Re: **121 E. Wilson Street – Alteration to Approved Plans**

121 E. Wilson Street

02/13/2023 URBAN DESIGN COMMISSION REVIEW

**BUILDING
ELEVATIONS - BW**

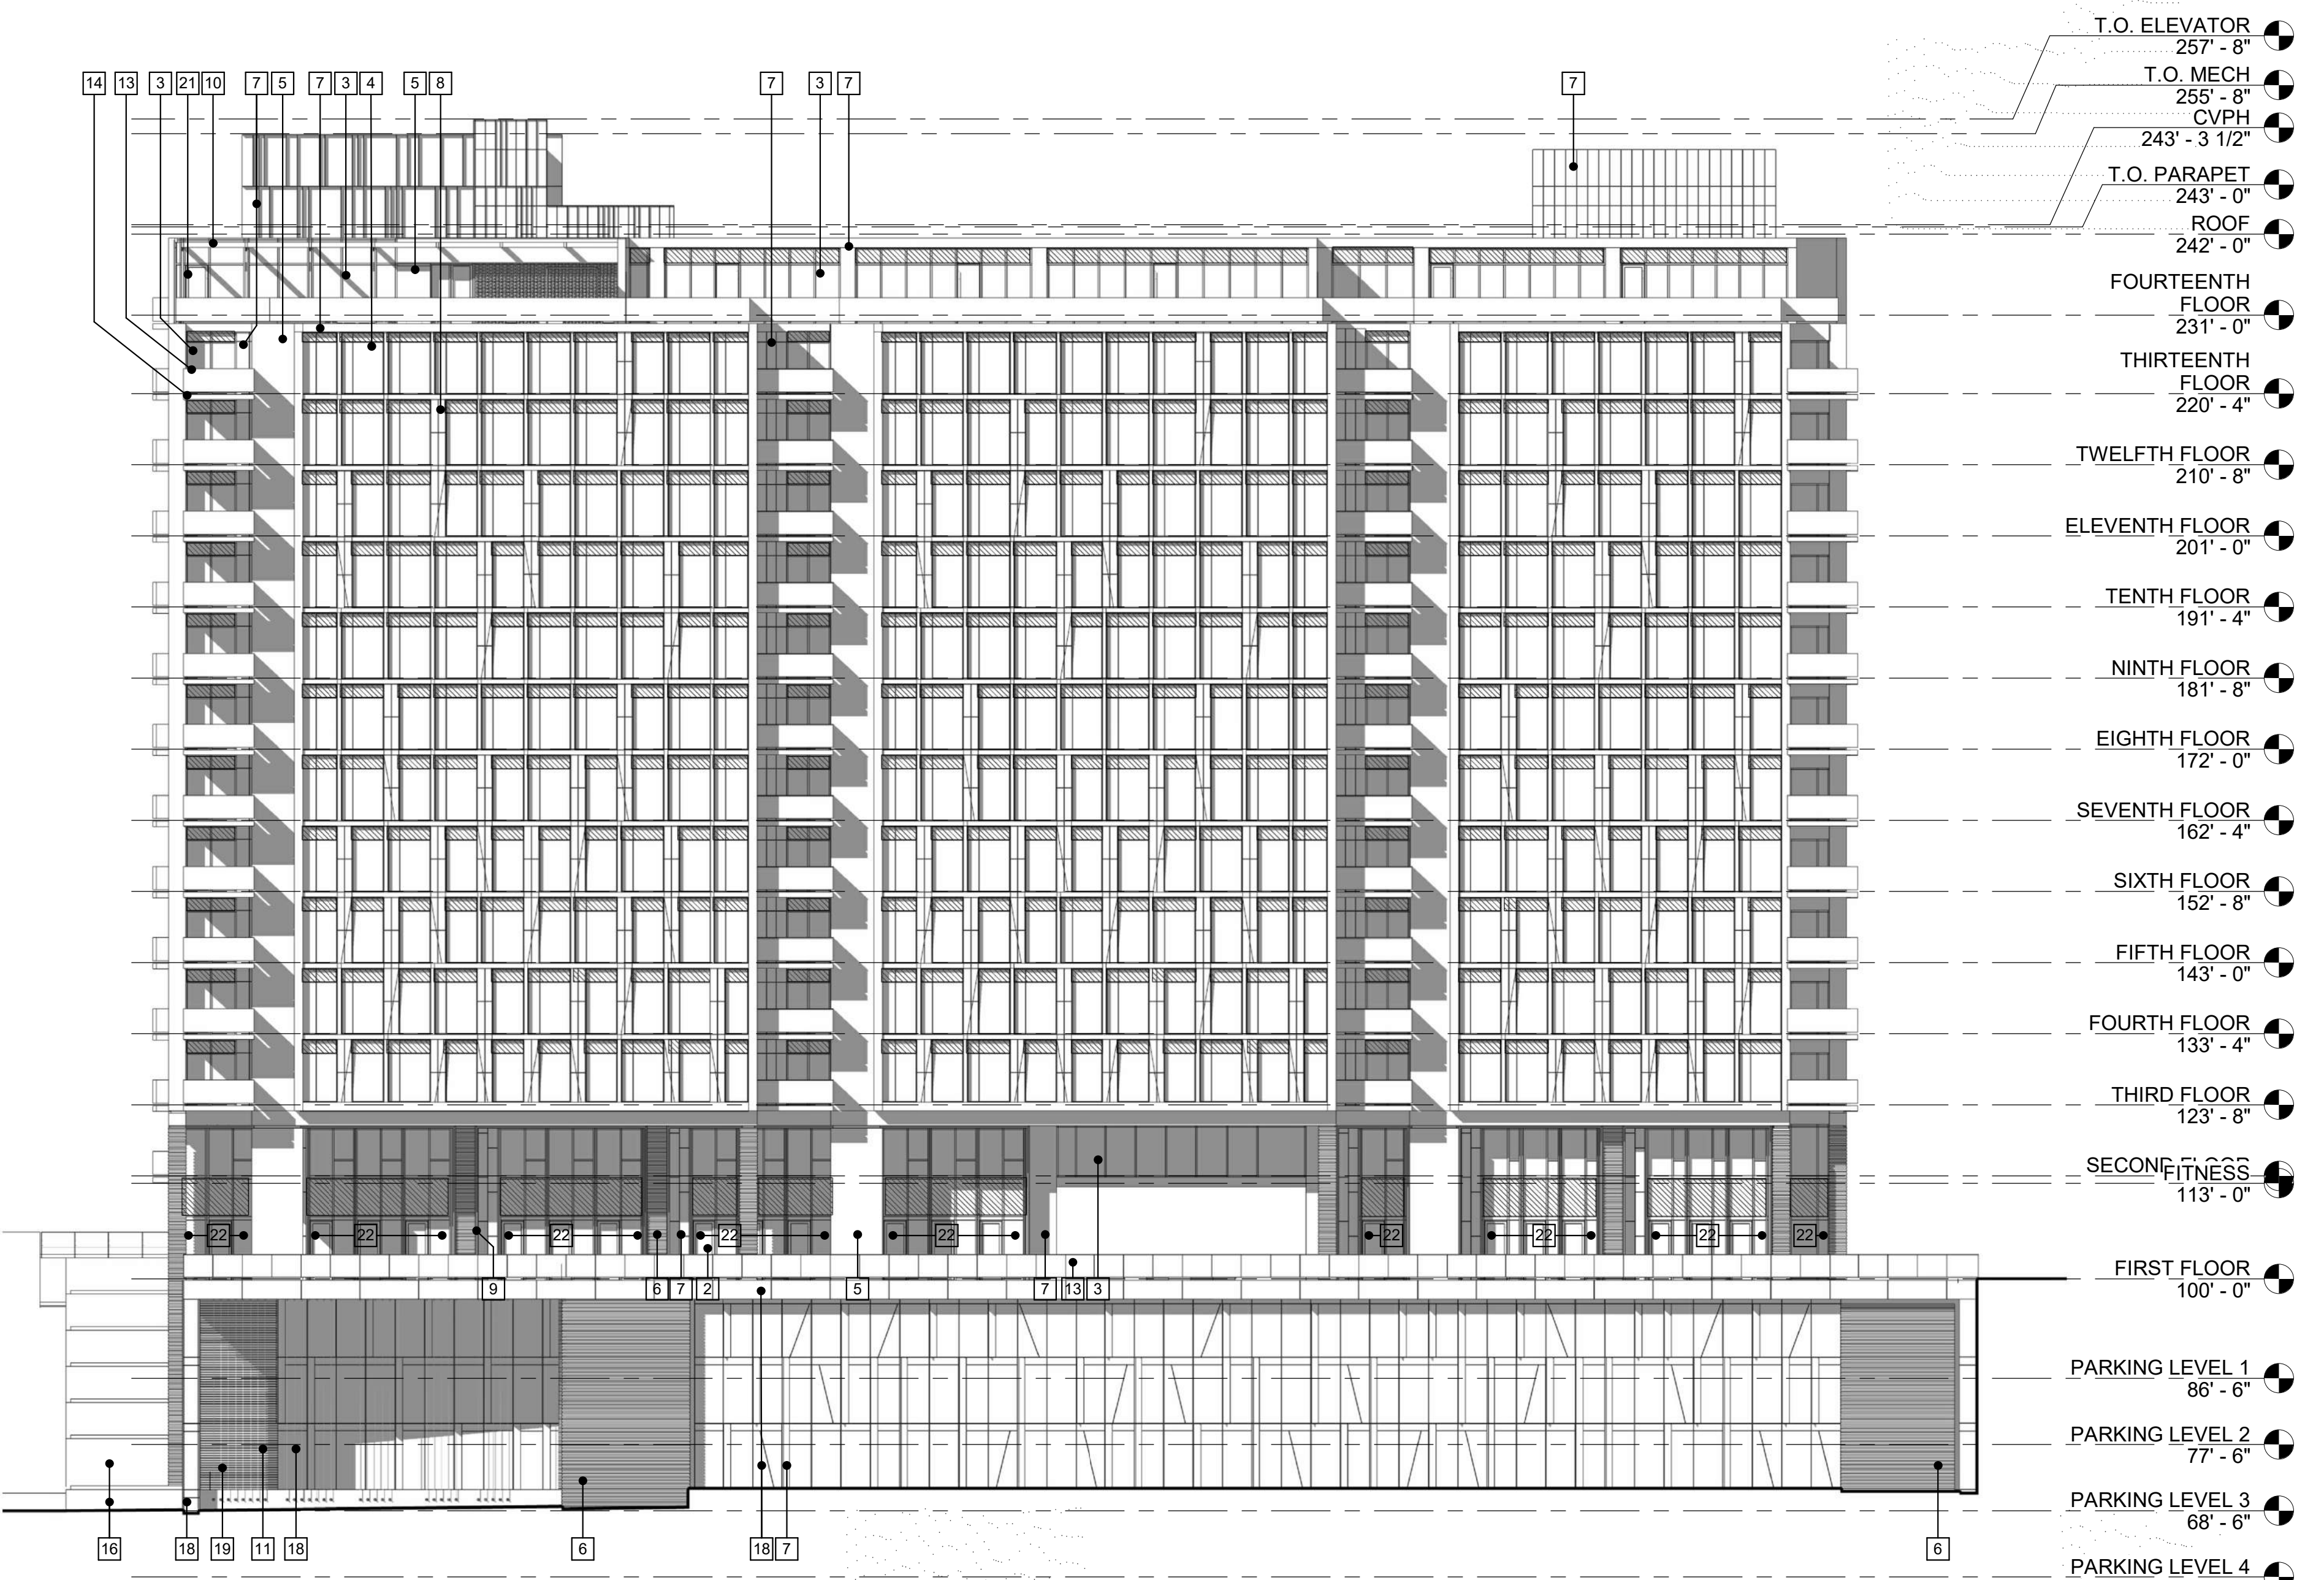
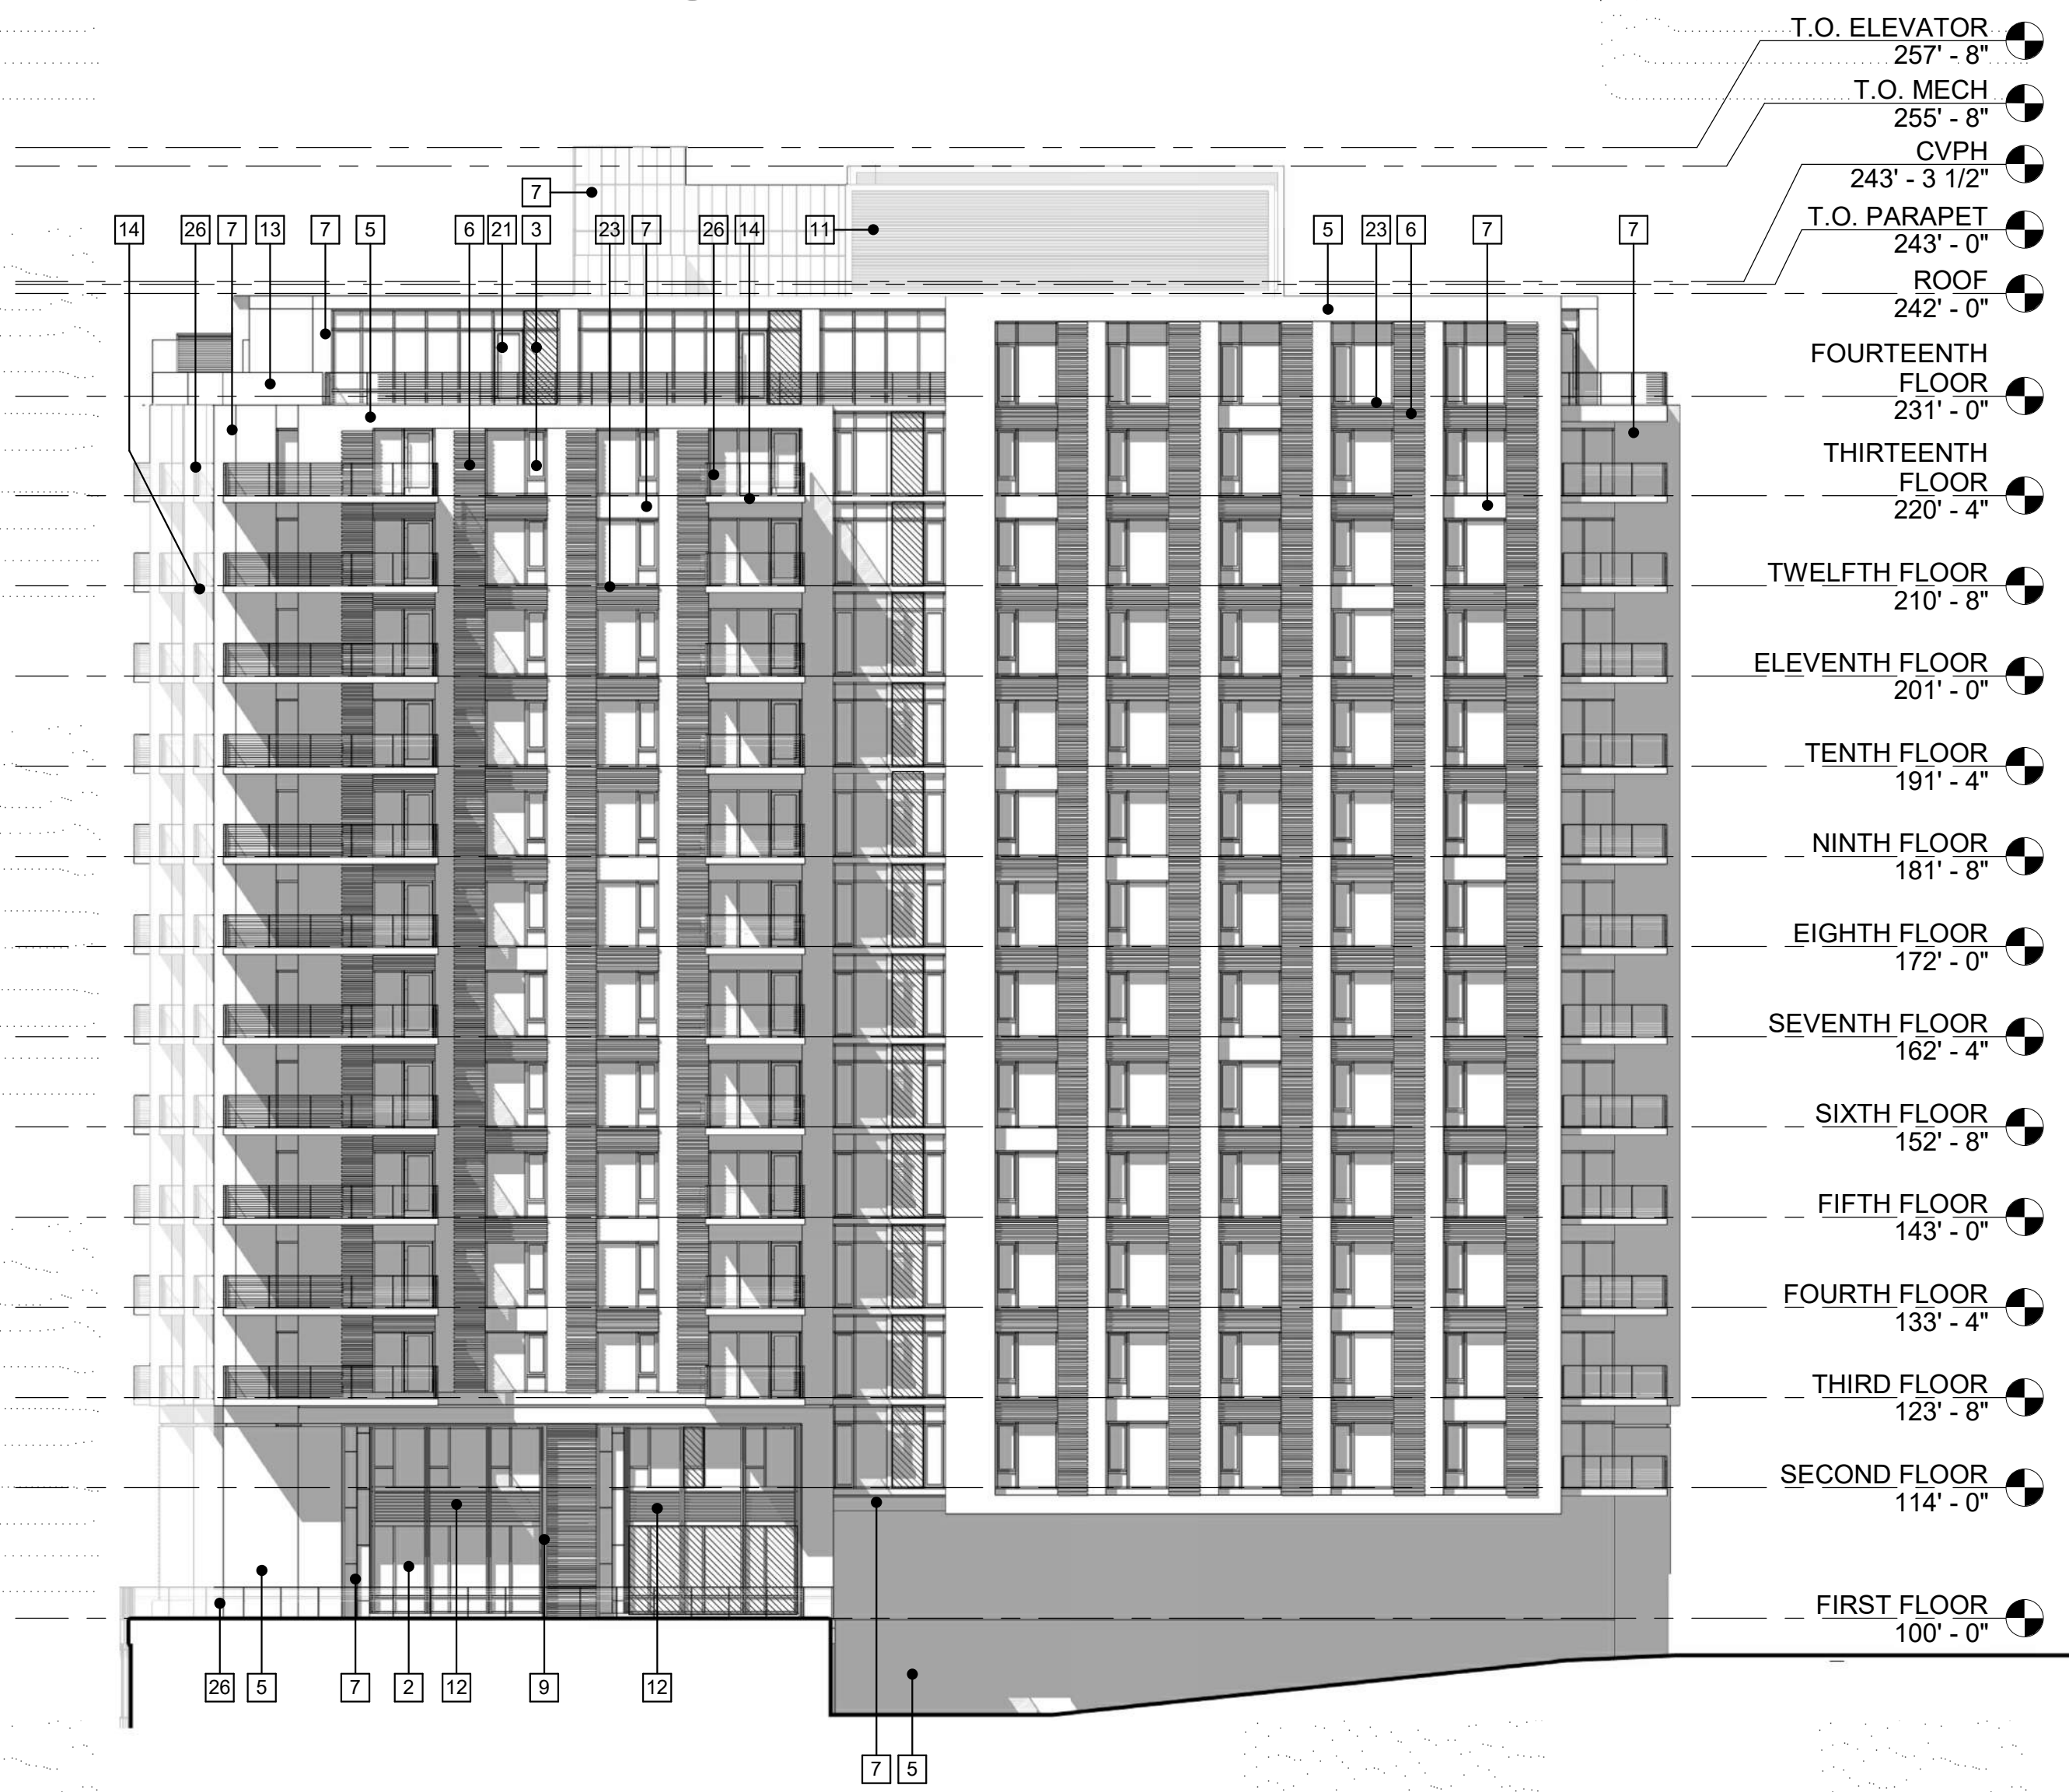
- The most significant change is a shift in the form and arrangement of the Concealed Fastener Metal Panels that occur on the Wilson St and John Nolen Dr facade.

- Previously the metal panels were scattered “randomly” across the facade while their quantity was reduced as you moved up the facade. The accent within the metal panels was a pleated form that pushed inward.

- Currently the metal panels are clustered around internal demising walls and where heat pumps are located along the exterior. The randomness is reintroduced by increasing the frequency of the pleat accent, which is now a folded accent. The metal panels fold outwards in either a left or right justification in a composed pattern. Similar to the original concept, the metal panels become less dense as they move up the facade.
